On Monday, July 1, 2013, at 5:00 p.m., in Conference Room A, 281 North College Avenue, Fort Collins, Colorado, a City of Fort Collins Hearing Officer will conduct a public hearing to consider a development project in your area. **The project is referred to as the 429 South Whitcomb Street Carriage House, Project Development Plan, #PDP130006.**

STAFF REPORT

PROJECT: 429 South Whitcomb Carriage House Project
Development Plan, PDP #130006.

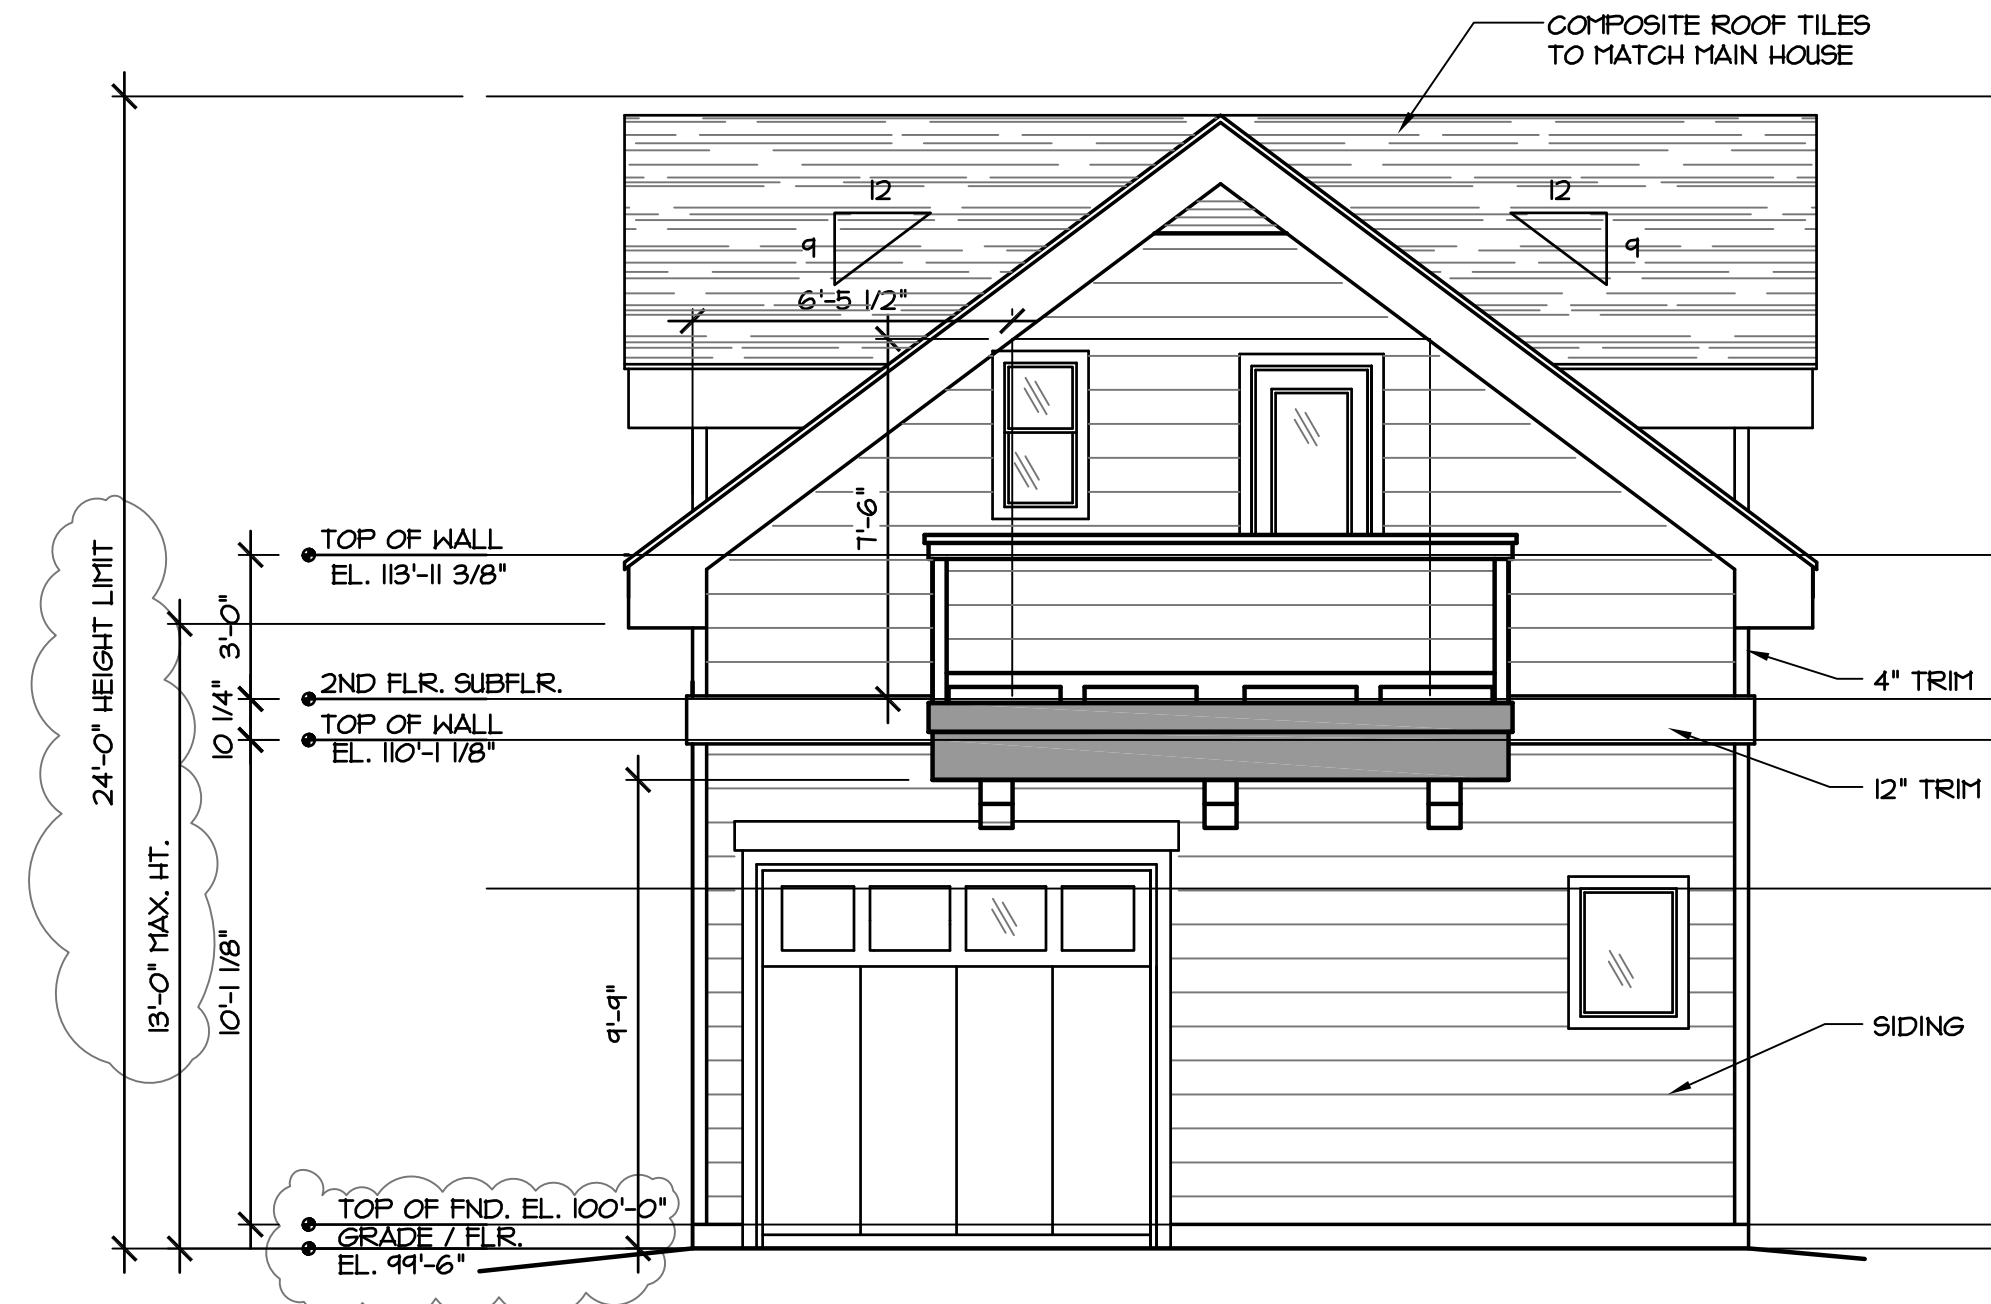
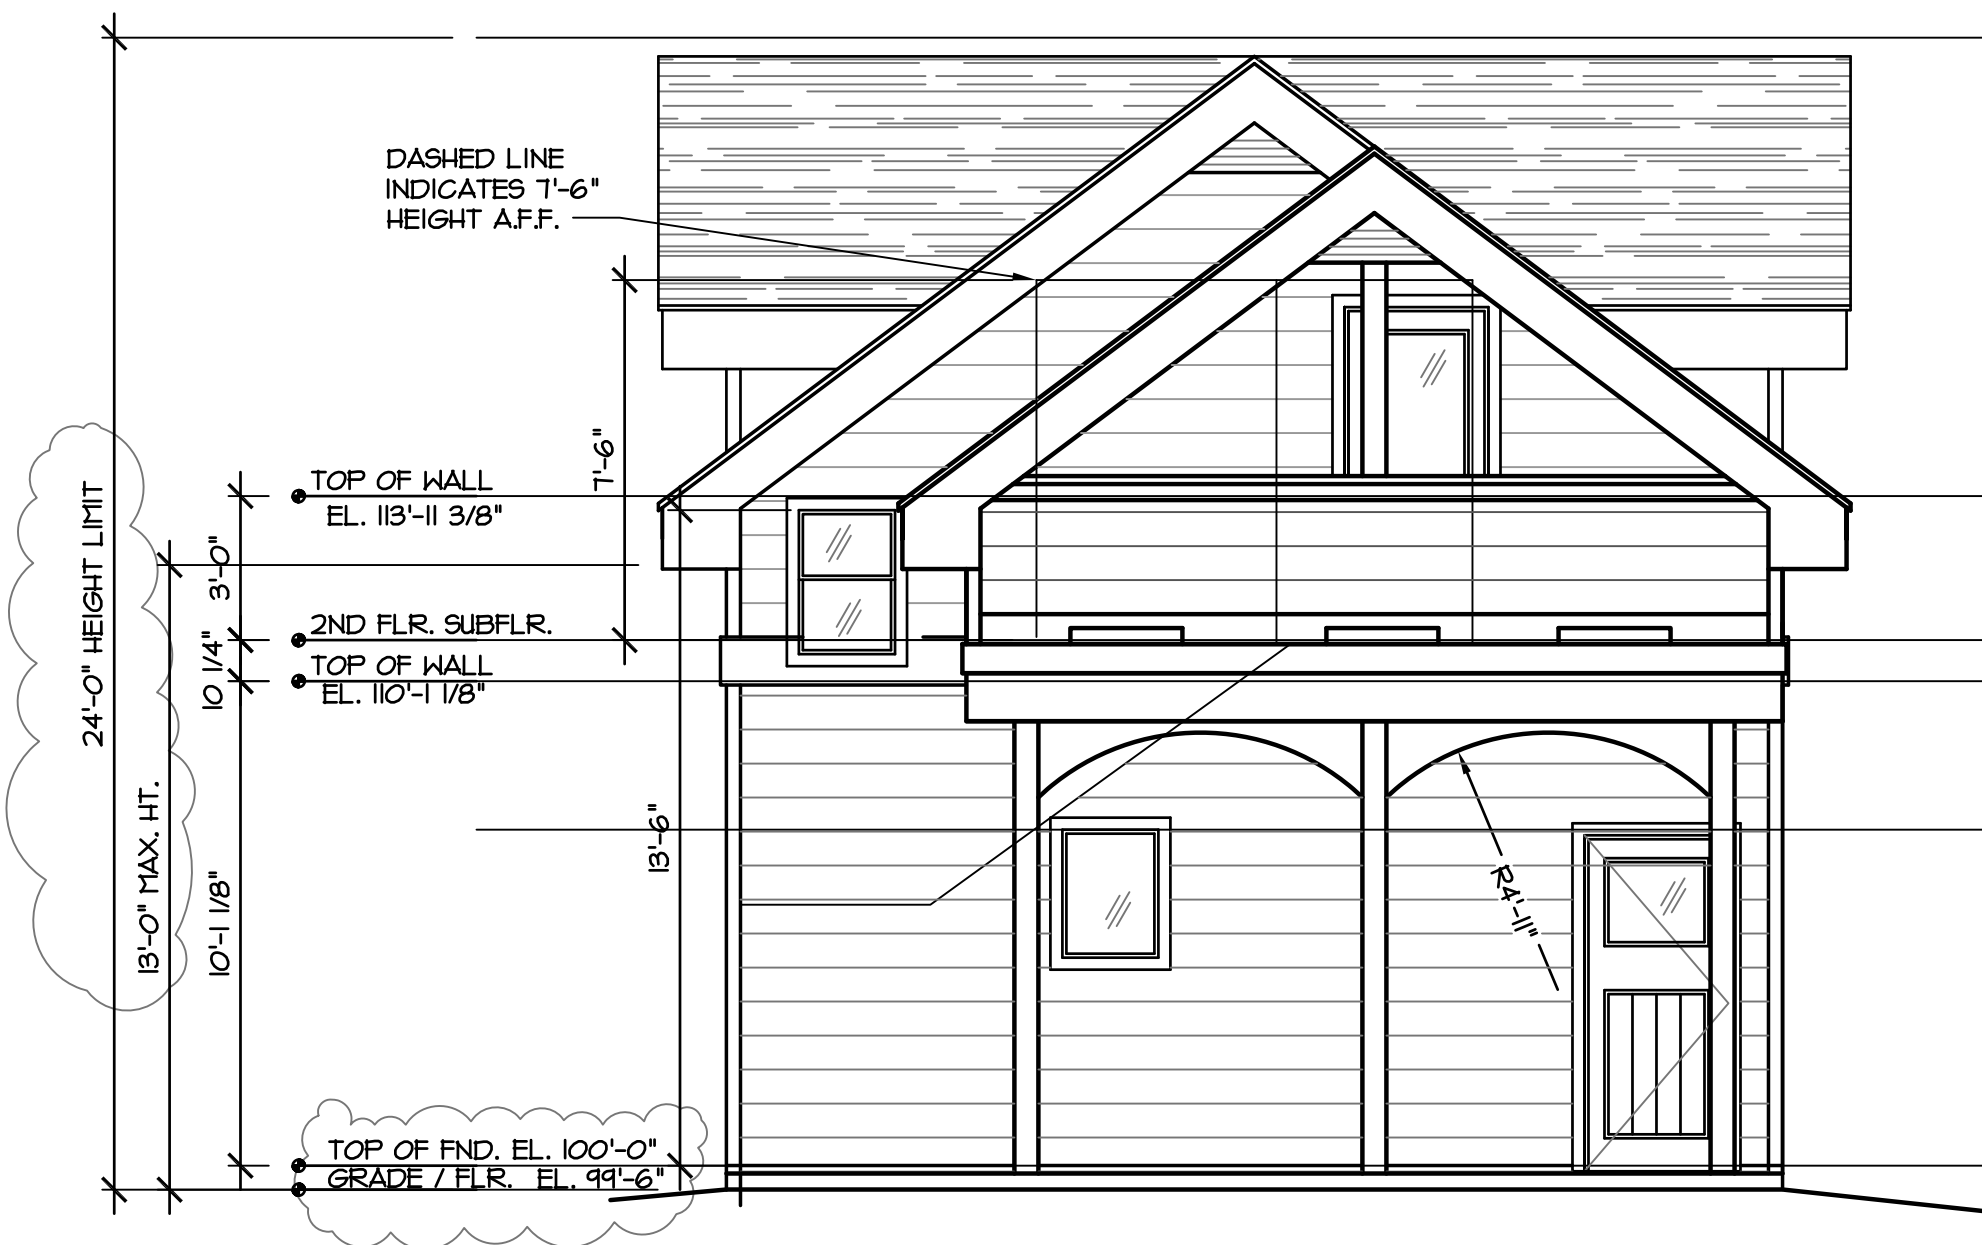
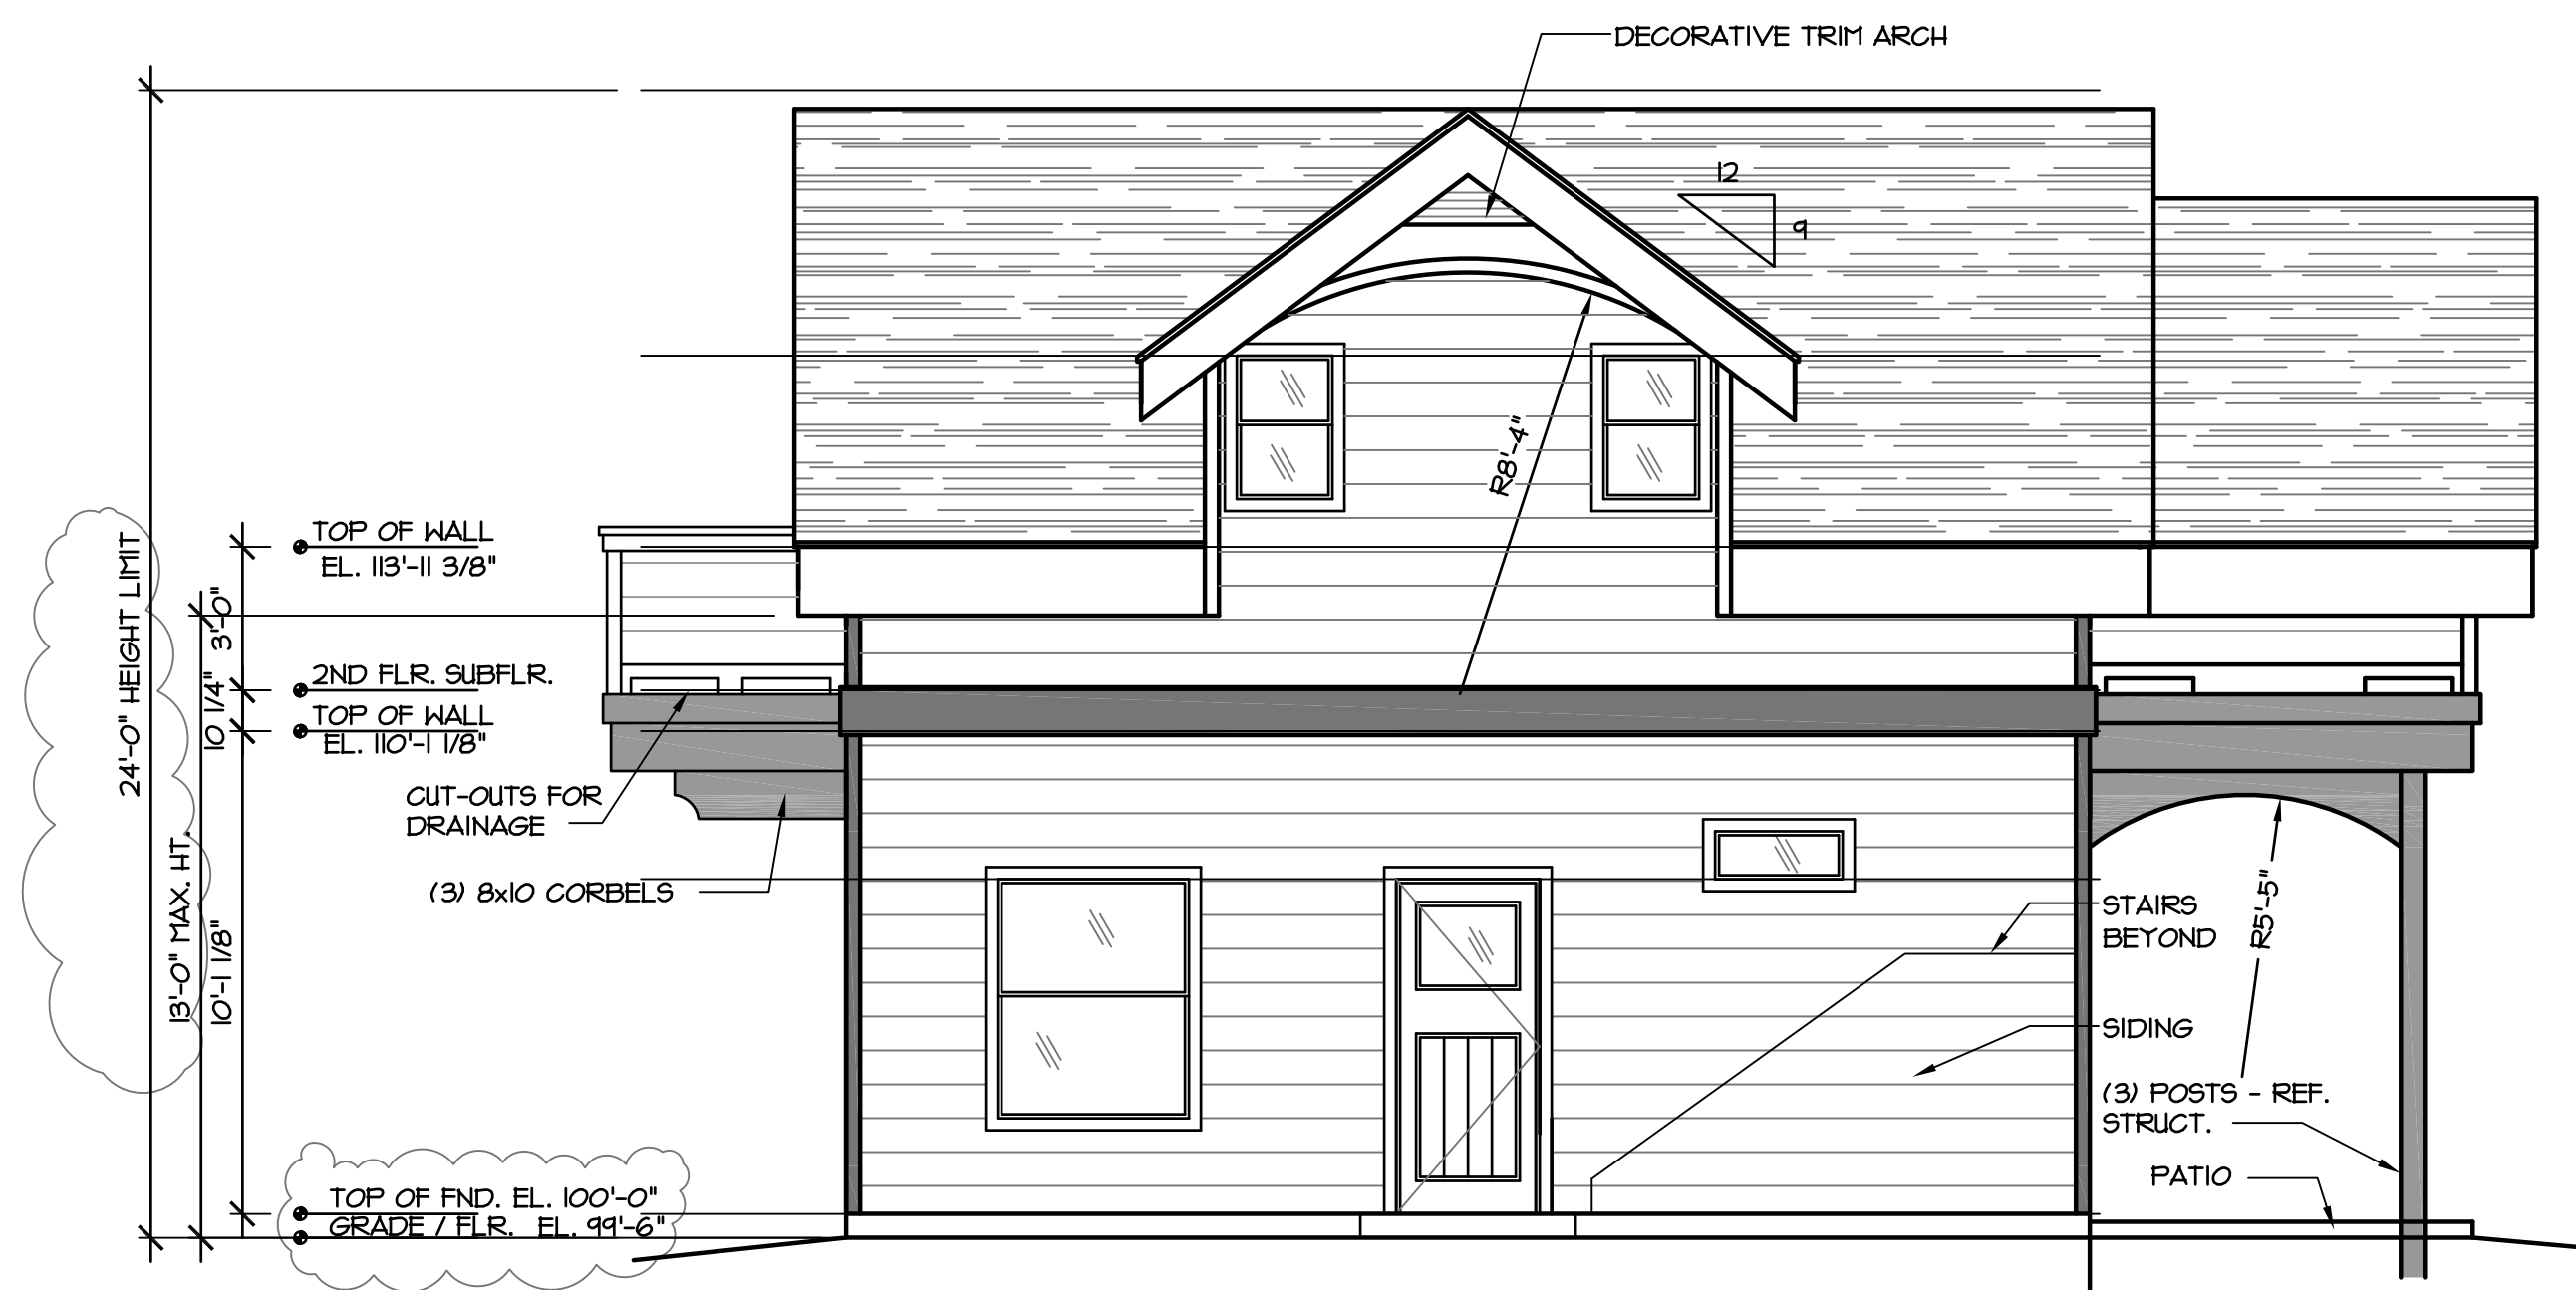
This standard limits the maximum building height for carriage houses to 1 ½ stories. To meet the 1 ½ story requirement, the roof line of the second story must be no more than 3 feet above the second story floor level; the carriage house building design is in compliance with this 3 feet configuration. The project is also in compliance with the maximum building height of 24 feet (4.8(F)(2)(a)(2).

The project is in compliance with all applicable building design standards of this section, which require that buildings be constructed at right angles to the lot, that the primary entrance be located along the front wall of the building, that an accessory building be located at least 10 feet behind the principal building, that the second floor not overhang the lower front or side of the building, that the front

porch proposed is limited to one story, and that the roof pitch is between 2:12 and 12:12.

- The Primary Elements of the proposed architecture – the overall outline of the dwelling, the use of gables and porch elements, and the use of second-story elements that are integrated into the roof line – are designed with a moderate size, bulk, and massing that provide an appropriate transition and compatible fit with existing homes in on the block.

- An appropriate number of secondary elements such as bay windows, porch elements, and roof dormers are provided that are appropriate in size, scale and proportion so that these elements do not overpower the overall building form while providing visual interest and articulated massing on all sides of the home.
